Panel Decision and Report

SRP FLPBC013123

Palm Beach County, FL

January 4, 2024

Figure 4. PFD - Transect 18 South of Lake Worth Inlet (Baird 2020b).

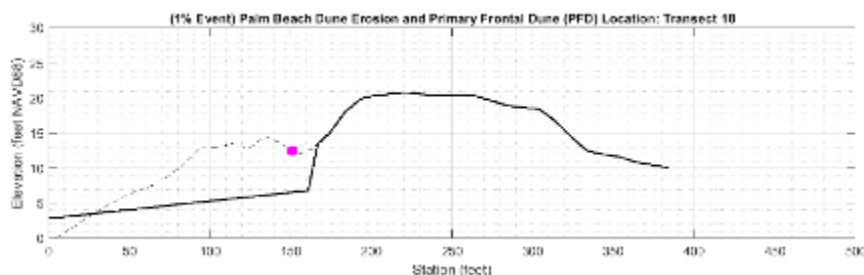
APPELLANT: The appellant identified several transects related to dune removal procedures and Primary Frontal Dune (PFD) locations. Appellant provided several example figures of transect including the below (Figure 4):

FINDING: The Appellant has valid questions regarding FEMA mapping with regards to dune removal and PFD location, however updated analysis and mapping is ultimately required for submittal. The Appellant is correct that the 1:50 slope is standard however, FEMA mappers do have flexibility based on historical eroded profiles. The Panel agrees with FEMA's approach.

Figure 5.3: Dune Removal - Transect 134 (FEMA, 2019; [15]).

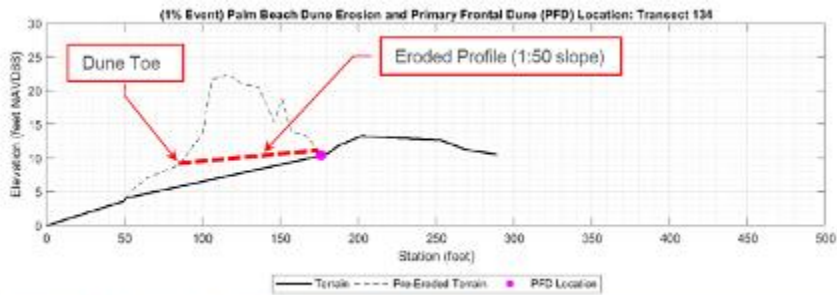
Figure 5. Note that "PFD" heel is identified in FEMA's IDS4-5 as the VE-zone delimiter for Transect 134, therefore the suggested adjusted slope would likely not impact the VE zone gutter position. However the suggested adjusted slope could affect BFEs and/or runup (Baird 2020b).

Figure 5.6: PFD - Transect 147 (FEMA, 2019; [15]).

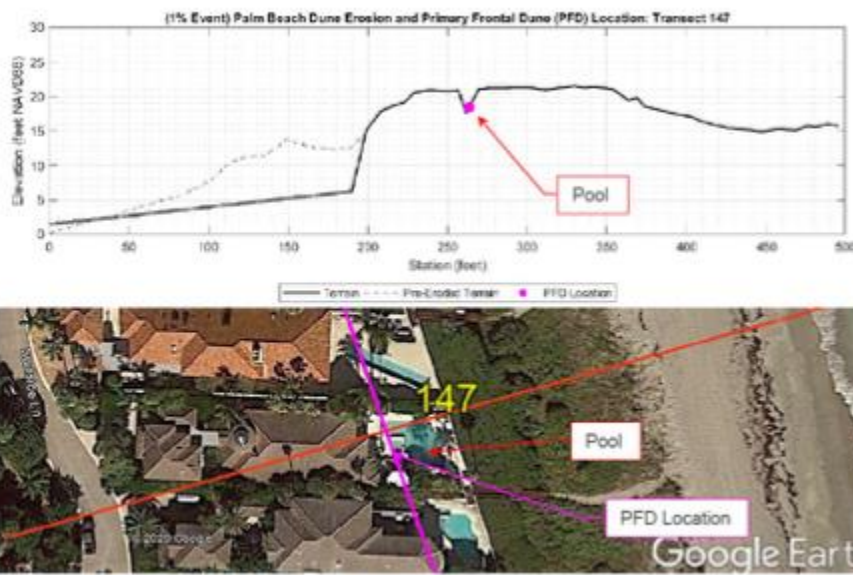
Figure 6: The appellant shows Transect 147 where the PFD crosses a swimming pool. Although not optimal, FEMA guidance does not explicitly oppose this mapping (and stresses mapping continuity) and more analysis is ultimately required to show changes in BFEs and flood zones (Baird 2020b).
